CCD1: Construction Code Determination Form

THE ABOVE REFERENCED BUILDING IS A NEW 9 STORY MIXED USE BUILDING.

ZRD1/CCD1 Response Form

Project:
MY MICRO NY
335 EAST 27th STREET
NEW YORK, NY 10016

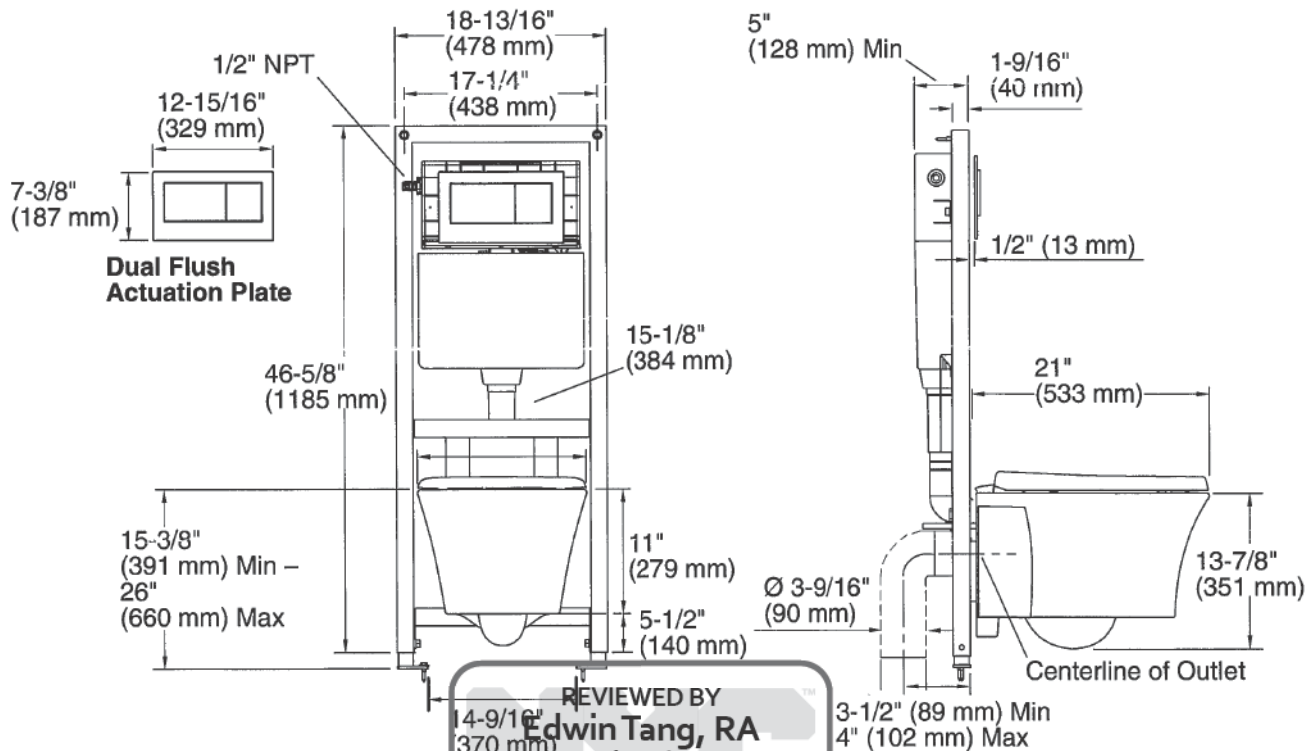
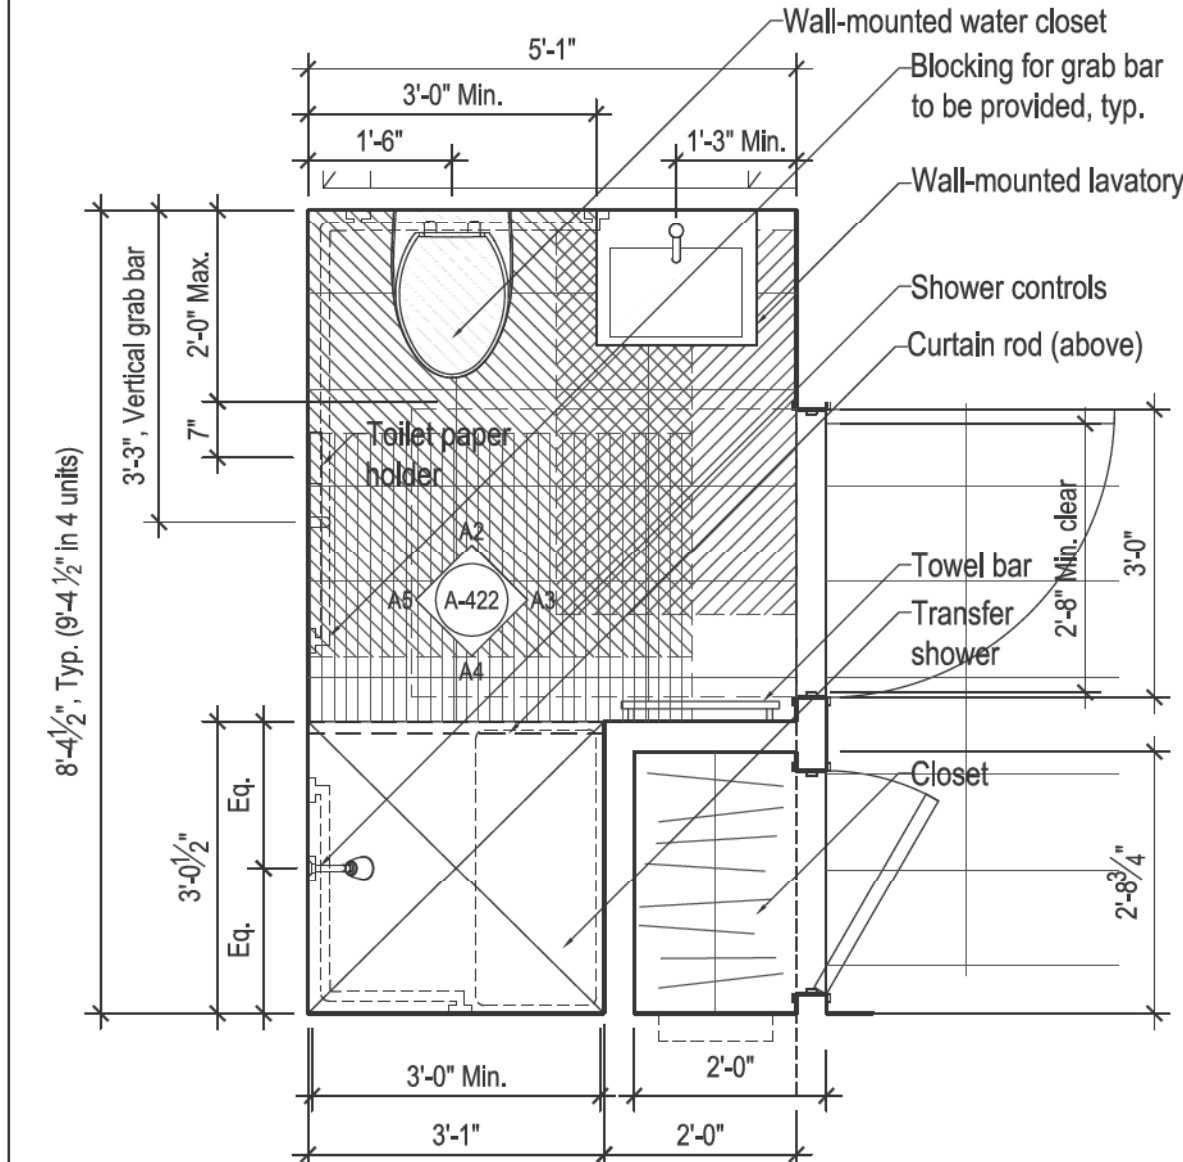
As per the attached plans, the size of the handicap bathrooms has been reduced while maintaining all code required clearances for handicap accessibility. The total bathroom size is able to be reduced because the selected toilet has the tank embedded in the wall. Please see the attached spec sheet of the toilet.

1. Tank of selected toilet shall not be embedded into a fire rated wall.

A1 BATHROOM PLAN: TYPE B-1 (QTY: 40 UNITS)
1/2" = 1'-0"

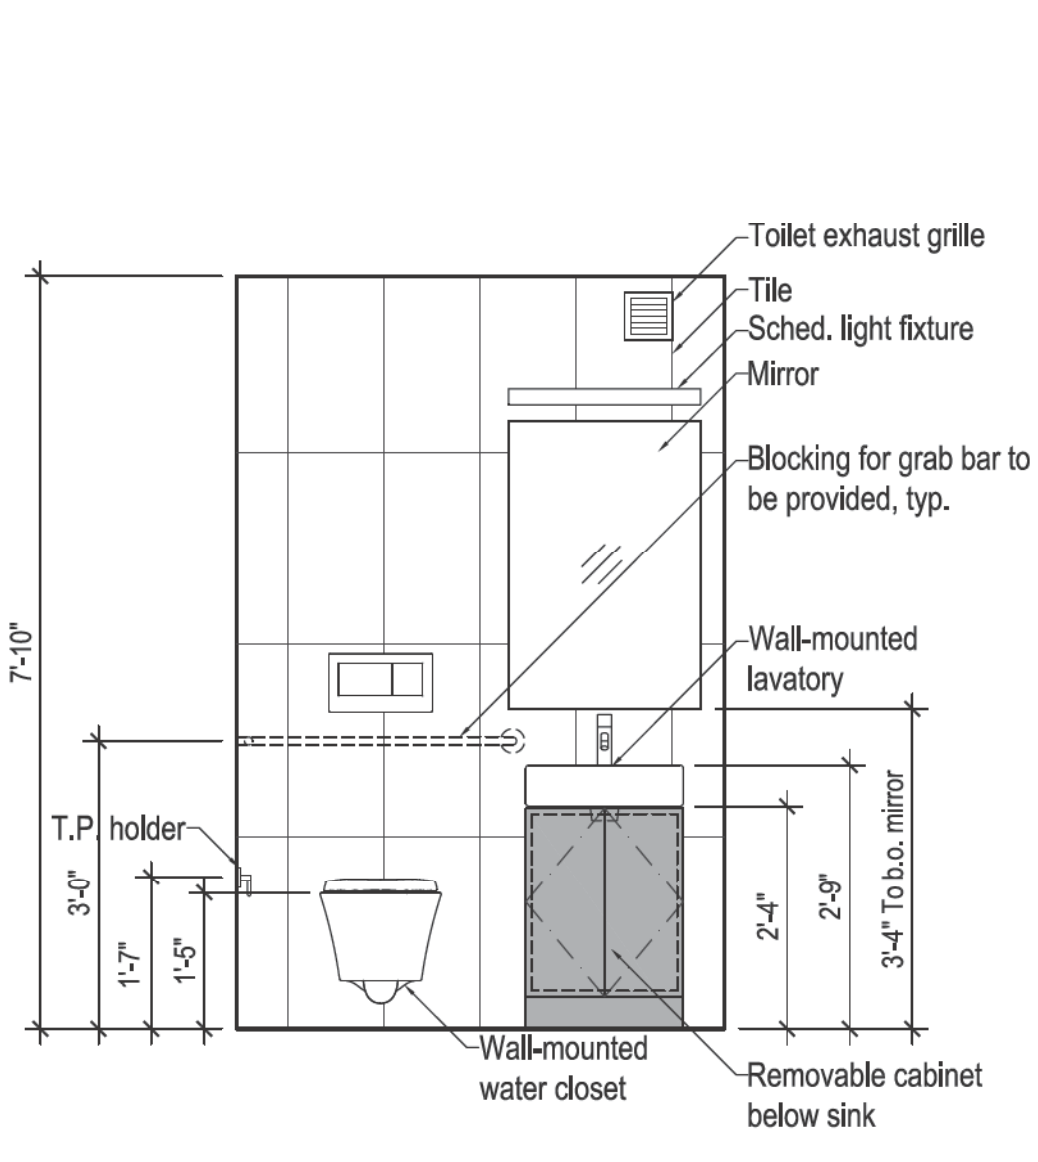
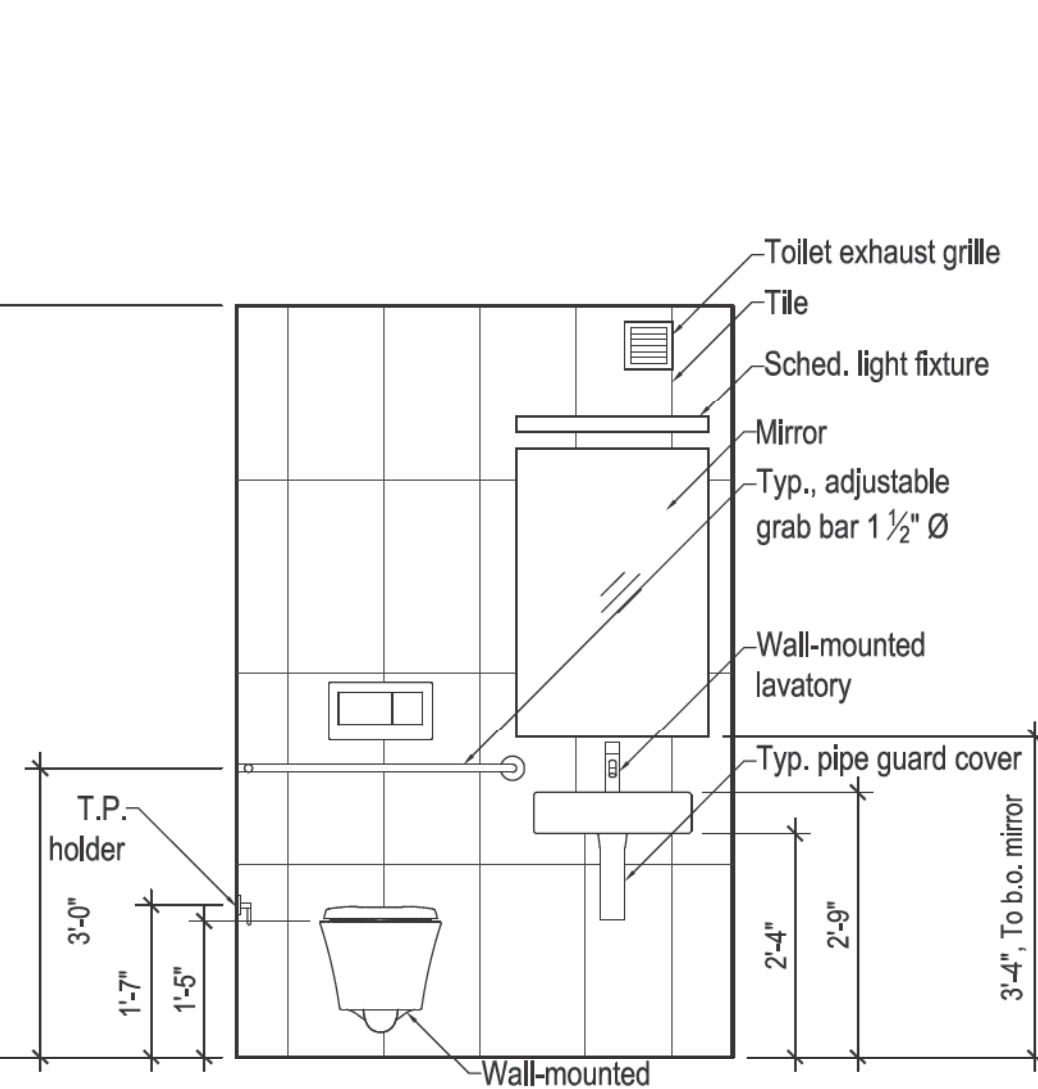
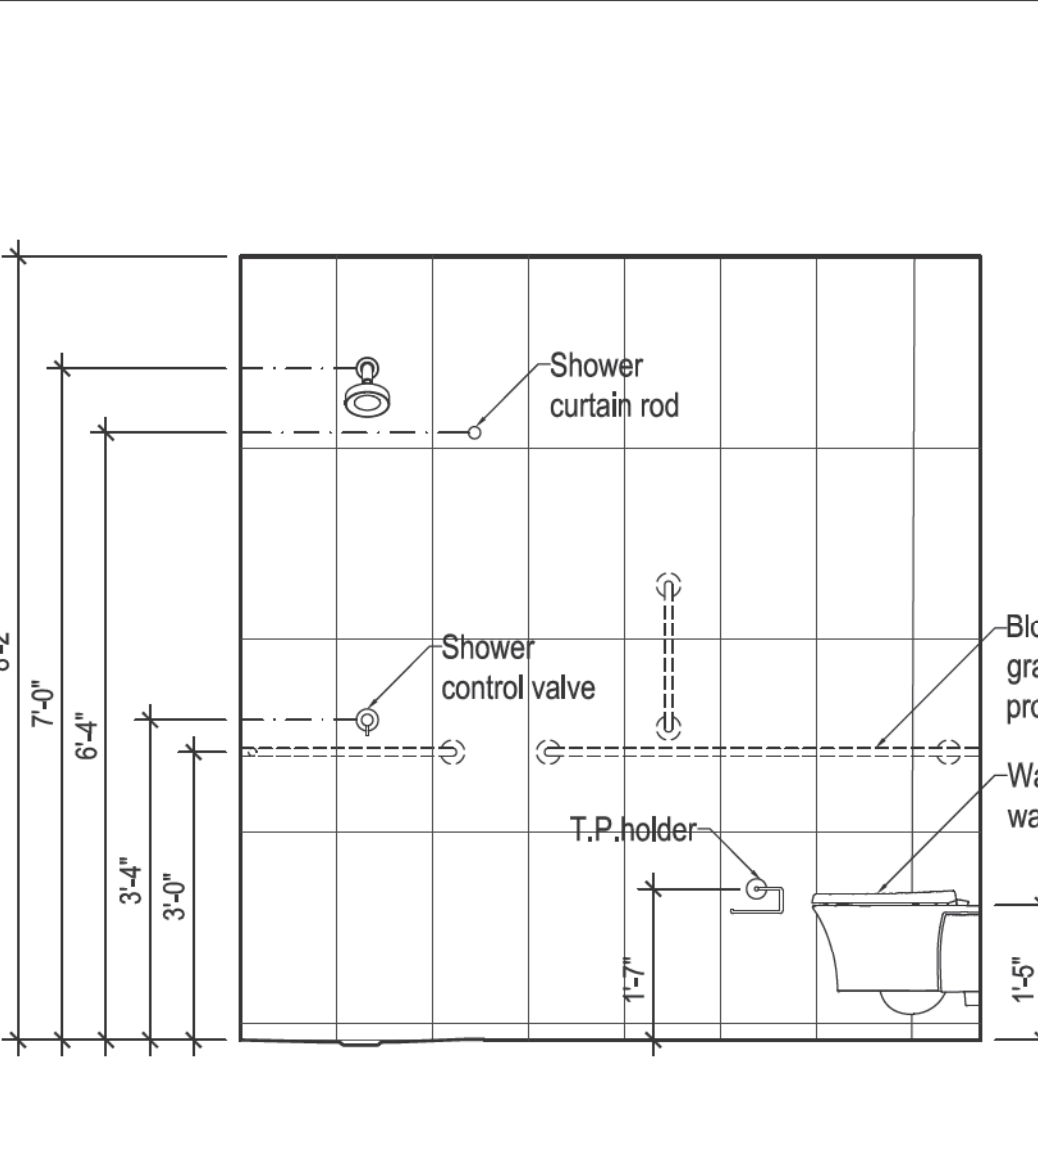
ICC A117.1, FHA, or the ADAAG does not prescribe the minimum length of the toilet seat. There is a section about wall-hung toilet but all it does is to allow a 3" reduction in clear floor space not applicable to Type B units.

All the other requirements are met (i.e. WC height between 17" to 19" AFF; 30" x 48" clear floor space for lav; 56" x 48" clear floor space for WC; 42" clearance perpendicular to the door etc.).

Please permit the size of the bathrooms as shown on the attached plans.

The request to permit the size of the bathrooms of referenced building is hereby approved with the following condition:
